Addendum for Bid
James River Interceptor Division 3B
14-876

Date: November 7, 2013
From: Stephanie Suter, CPPO, CPPB
RE: Addendum No. 2

Addendum No. 2 for City of Lynchburg, James River Interceptor, Division 3B, City Project No. 13023-S: Commission No. 213169.00, dated November 7, 2013.

PROJECT JAMES RIVER INTERCEPTOR DIVISION 3B		TITLE CSO #56 PLAN	
COMM. NO. 213169.00		DRAWN SMF	
DRAWN SMF		CHECKED SMF	
DWG. REFERENCE NO. S-101			
SHEET TITLE SSK-1			
DATE 10/30/13		REV. ----

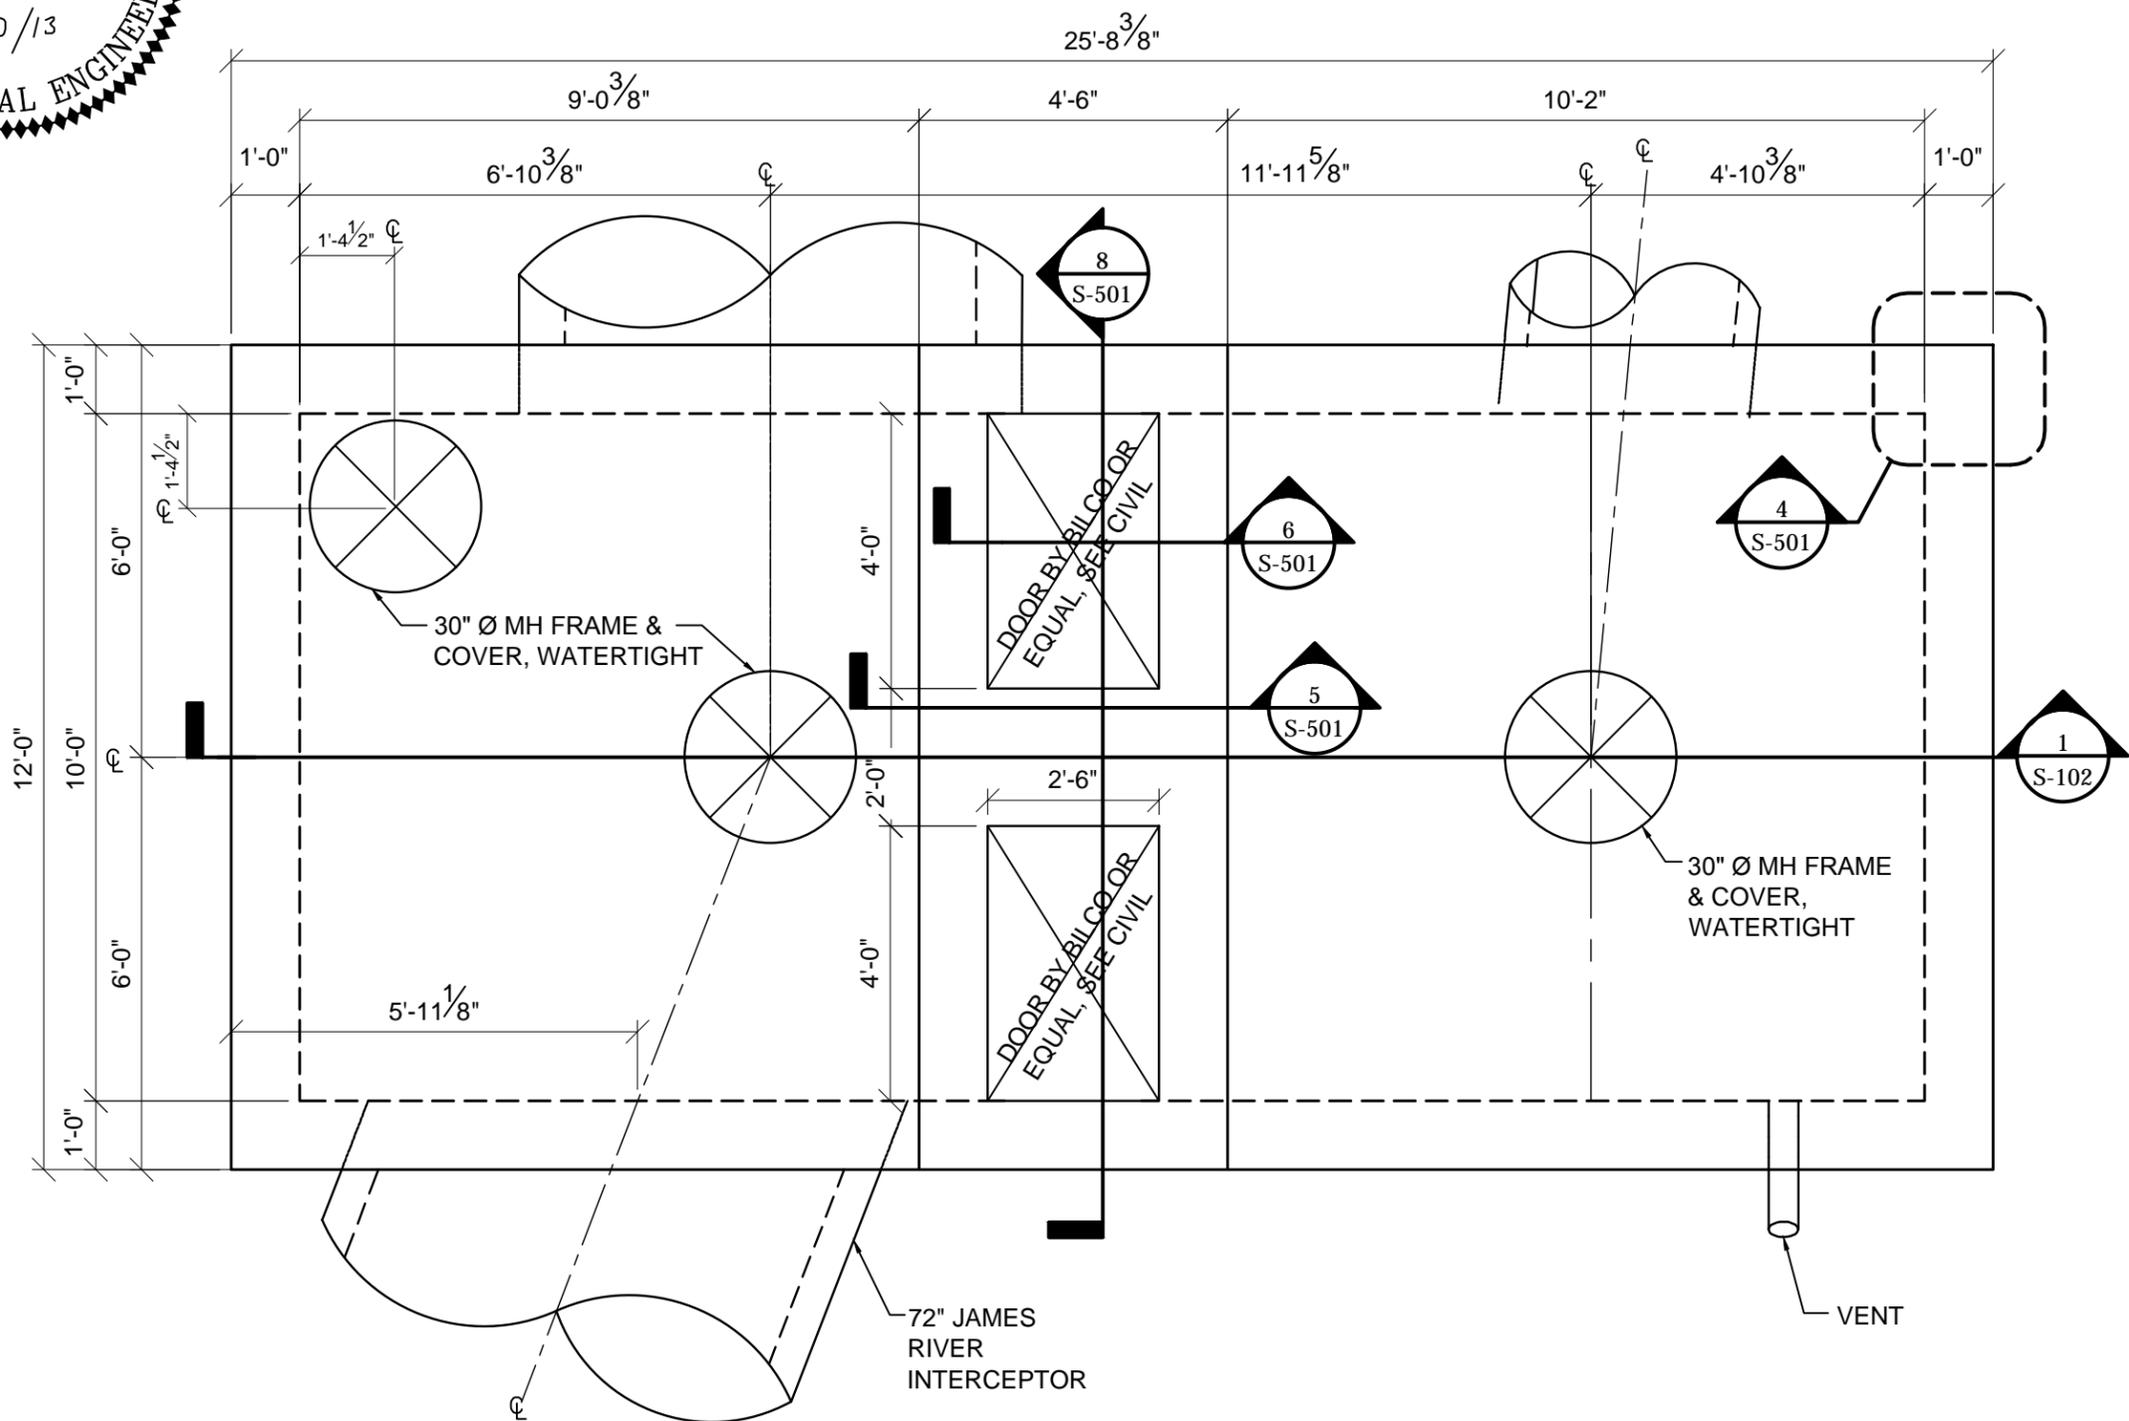
Drawings SSK-1, SSK-2, SSK-3, and SSK-4

Add to Contract Documents

1 EAST PRECINCT PLANTING PLAN
L-402 SCALE 1" = 10'-0"

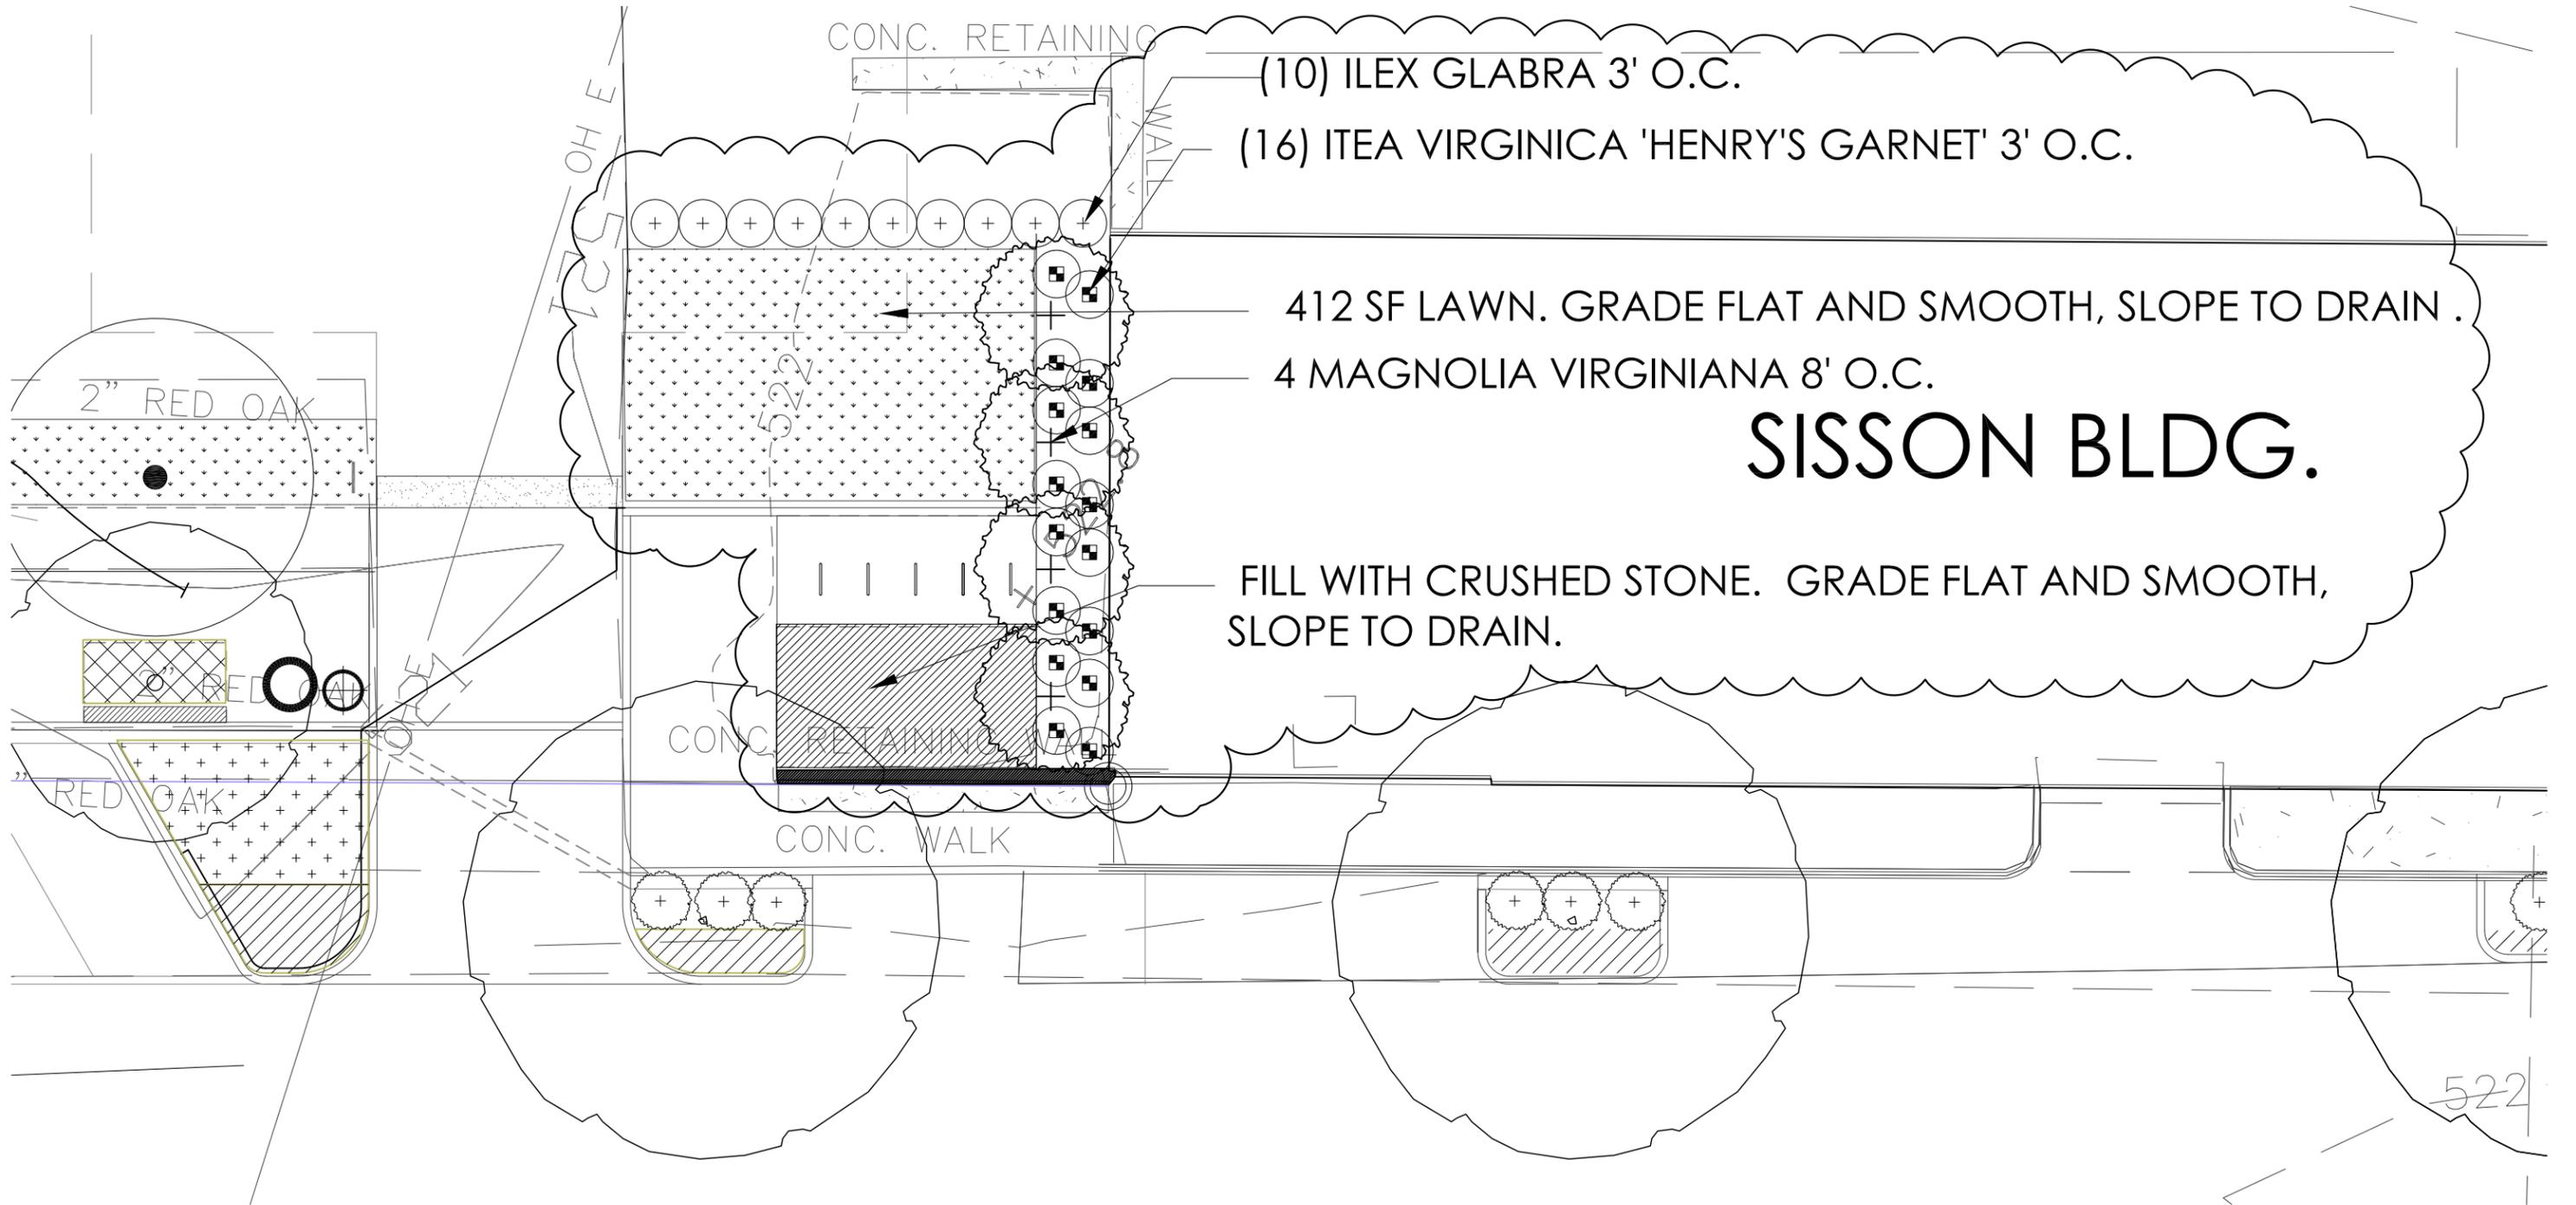
NOTE: 3 ILEX GLABRA, 2 ITEA VIRGINICA, AND 410 SF OF LAWN ADDED FROM WHAT IS SHOWN IN 100% DRAWINGS.

2 EAST (and CENTER) PRECINCT GRADING PLAN
SCALE 1" = 20'-0"

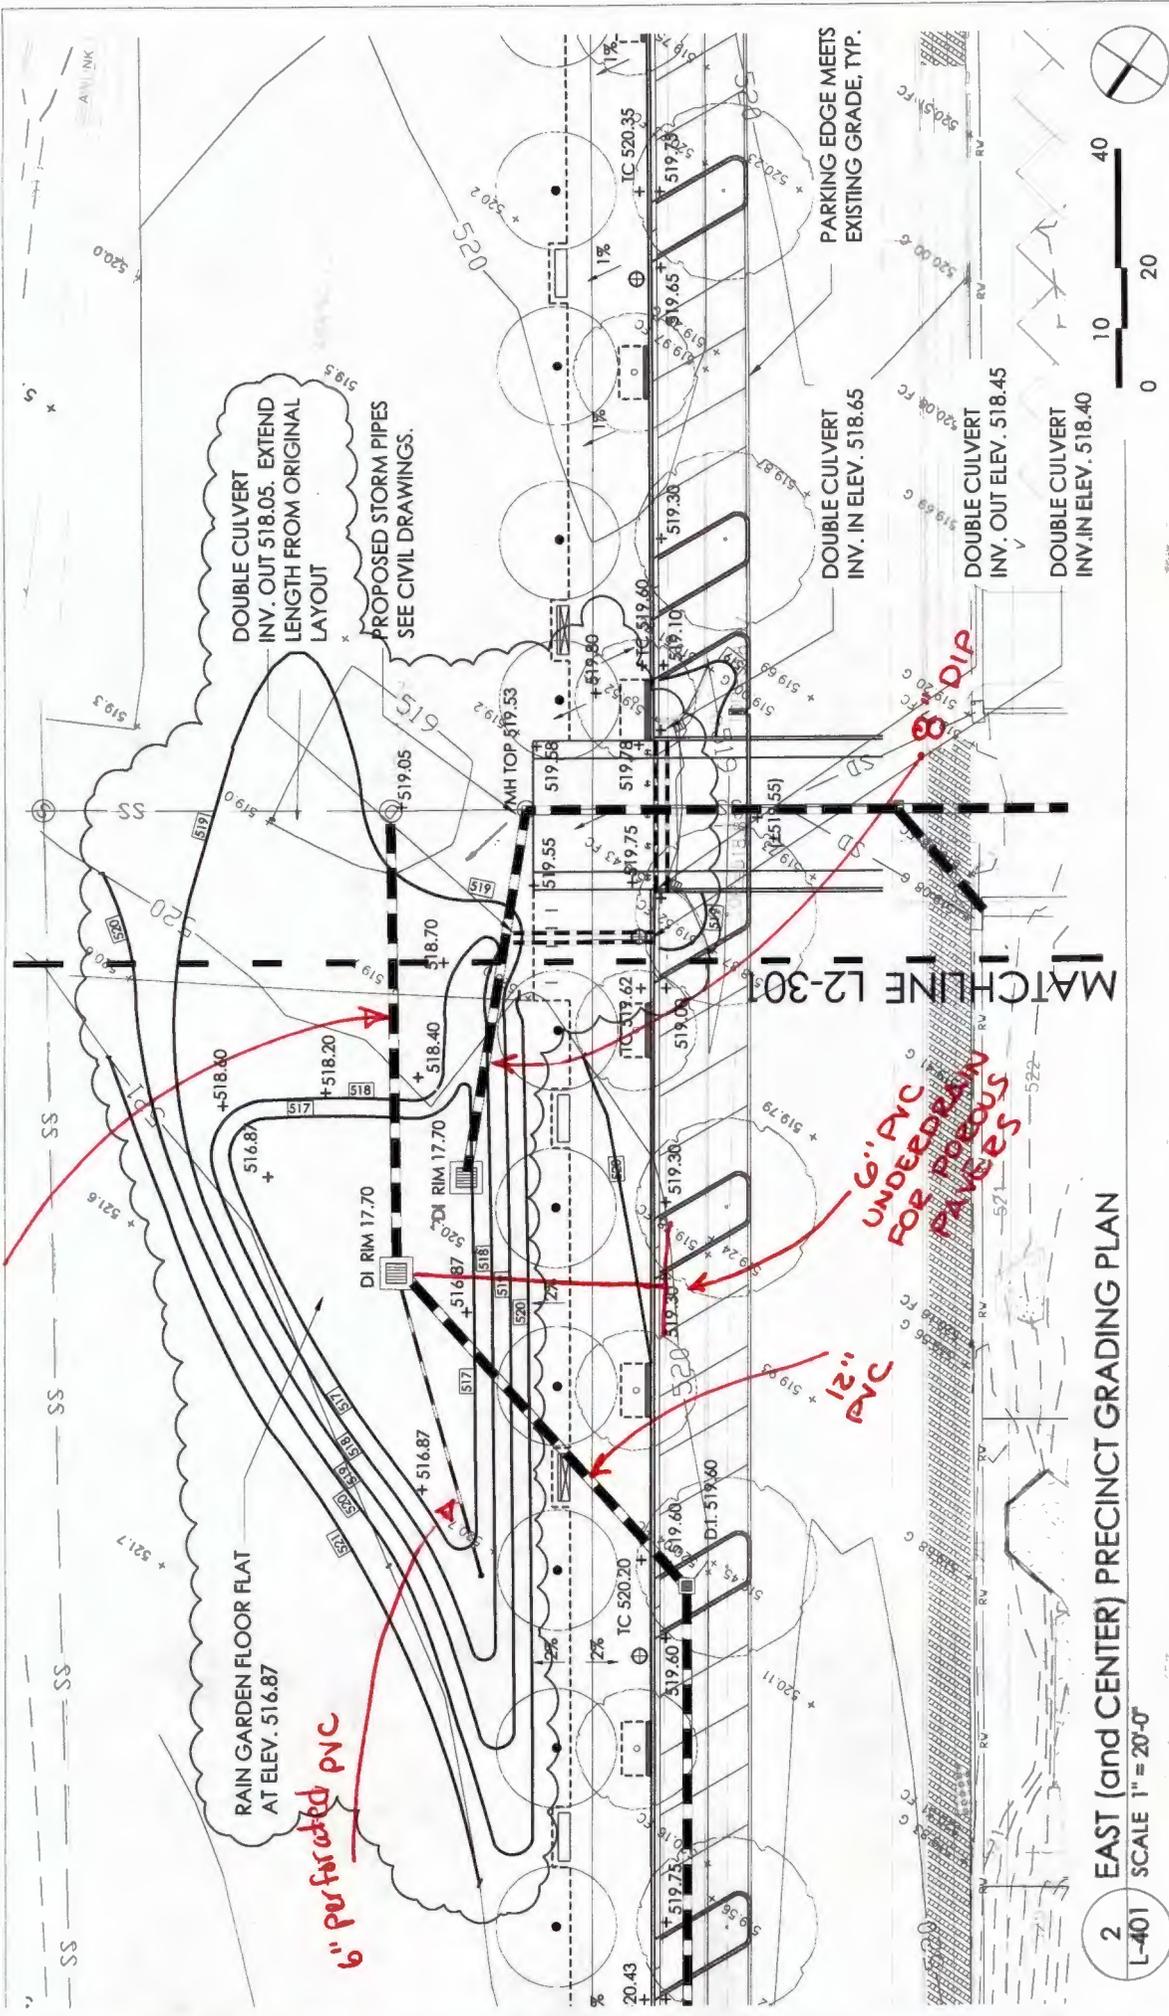
Attached is the an SK showing the modification to the grades at the sidewalk and rain garden at 13th Street related to elevation changes to structure 12 and lowering the rain garden . Please issue to the contractor if you approve . Let me know if the contractor needs a CAD version for layout .

3. For STW 12 , first lower the rain garden to elevation floor elevation to 516.87 and lower the top of the structures 10 and 11 to 517.70. In STR 12 crest elev. of the weir in is to be 518.03. The top of the manhole is to be 519.53 use a 4" thick lid . This will give 6" clear over weir for overflow. This change will mean a certain amount of minor re-grading in this area to make sure the grades work with the new top and the rain garden has the same capacity.
